Determination 2016/004

Regarding the weathertightness of some 19-year-old stucco plaster walls to a house at 467 Mill Road North, Invercargill (to be read in conjunction with Determination 2015/040)

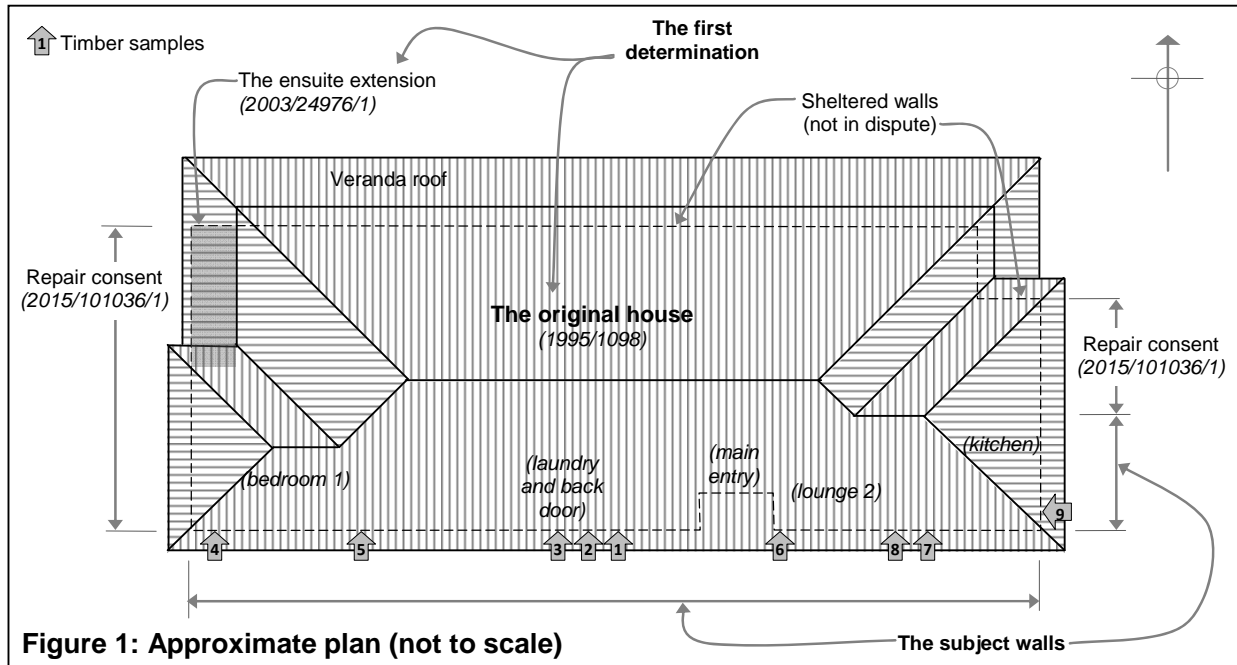
- 5.4.3 To further investigate the condition of framing in the laundry area, the expert removed skirtings and made cut-outs through the lining (see Figure 1). The expert forwarded timber samples for analysis and recorded invasive moisture readings of:

- 18% at the past plumbing leak, with water stains and decay evident (Sample 1)
 - 21% at mid-point of the bottom plate with timber appearing sound (Sample 2)

- 14% at the sill/jamb junction with timber appearing sound (Sample 3).
- 5.4.4 The expert also took invasive moisture readings through the stucco into bottom plates at four other locations on the south and east walls, recording readings from 18% to 20%, which were not considered concerning on the cold south wall. However, after receipt of the laboratory report for Samples 1 to 3 (see paragraph 5.5.1), the expert returned to the site to undertake additional investigation.

- 5.4.5 To further investigate the condition of the bottom plate, the expert removed trim and made cut-outs through the lining (see Figure 1) and observed that the timber 'in every location was of visually sound timber, free from any obvious moisture, staining, mould or degradation.'
